JX2-SV1 and CAN-DIMA

Version Update

JX2-SV1, Versions 1.25 to 1.33

CAN-DIMA, Versions 1.20 to 1.28

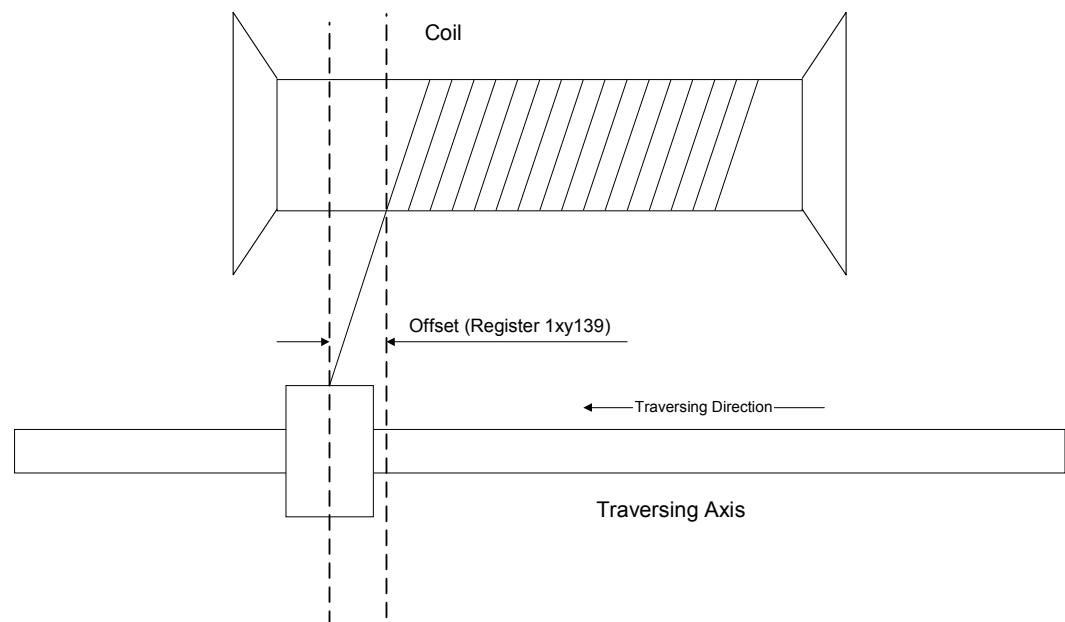
Now, it is possible to have the traversing axis run ahead of the actual winding position at the coil. For some winding material, it will be necessary to position the contact point between winding axis and winding material ahead of the contact point on the spindle; this way, for example, the material can be applied to the coil in "diagonal" mode.

Register 1x139	Offset to the internal set position in the slave	
Function	**Description**
Read Access:	Present parameter value
Write Access:	A new parameter value is defined
Value Range:	0 .. 8388607 increments (of the traversing axis)
Value after Reset:	0

Other than in the follower control, the value can always be positive only, which means that the traversing axis can only run ahead of the contact point on the winding axis.

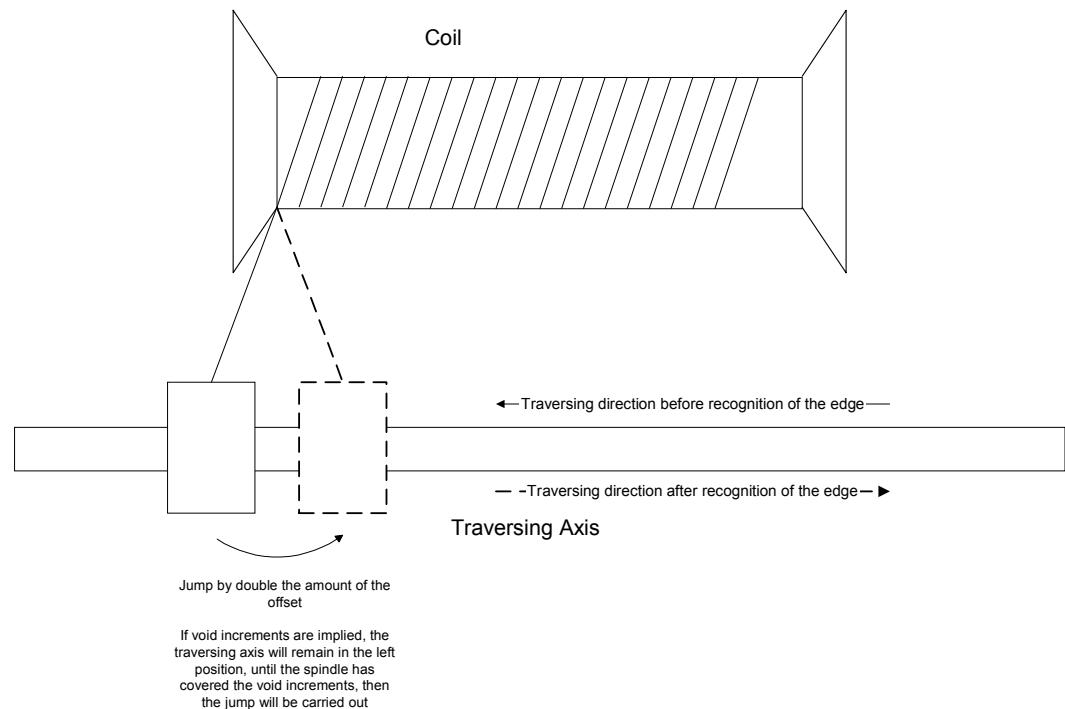
When the edge of the coil has been recognized (reversing of the trasversing axis is started), the offset will also "jump" towards the opposite direction; this will cause the traversing axis to run ahead of the winding material again by the value of register 1x139. As a consequence, the winding axis will run as fast as possible and by maximum acceleration from value (EDGE + OFFSET) to value (EDGE – OFFSET), respectively vice versa at the negative edge.

If void increments are applied at the edge of the coil, the traversing axis will remain on the position where it was when the edge was recognized, until the coil has covered the amount of increments defined in register 1x188 of the traversing axis. Then the offset will be applied (which is twice the value of register 1x139), and the next layer will be fed.

Jump by double the amount of the offset

If void increments are implied, the traversing axis will remain in the left position, until the spindle has covered the void increments, then the jump will be carried out

Example

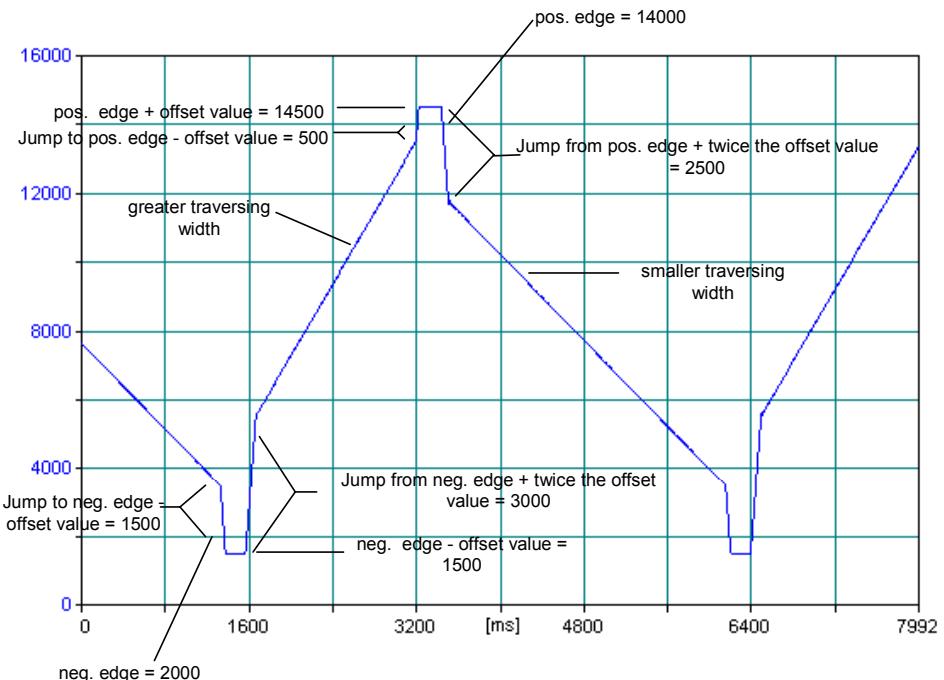
In the table below, the functioning principle will be illustrated once more:
All functions that are of any importance for processing the edge will be considered there.
When the respective parameters have been set to zero, their functions will be cleared from the table.

In this example, every layer of an uneven number will be wound by a larger traversing width than the layer of an even number.

Positive edge (1x193)	=	14000
Negative edge (1x194)	=	2000
Offset (1x139)	=	500
Void increments (1x188)	=	5000
Jumping distance to the positive edge (1x586)	=	1000
Jumping distance to the negative edge (1x587)	=	2000
Jumping distance from the positive edge (1x588)	=	1500
Jumping distance from the negative edge (1x589)	=	2000

One can realize by this illustration, that after a jump from the edge, the axis will, in the beginning, still be running by a greater speed than would correspond to the traversing width. The reason is the limited speed during the jump. At this point, the tracking error having been caused by the jump, will be decreased. This will be done by the speed defined in register 1x103. If the register value were incremented at that point, the steepness of the jump would be greater, while the time needed for going back to default traversing would be shorter. Yet, the traversing axis would become more prone to oscillating.

For this reason, please be careful to adjust the width and speed of the jump to the possibilities of the respective mechanical plant.
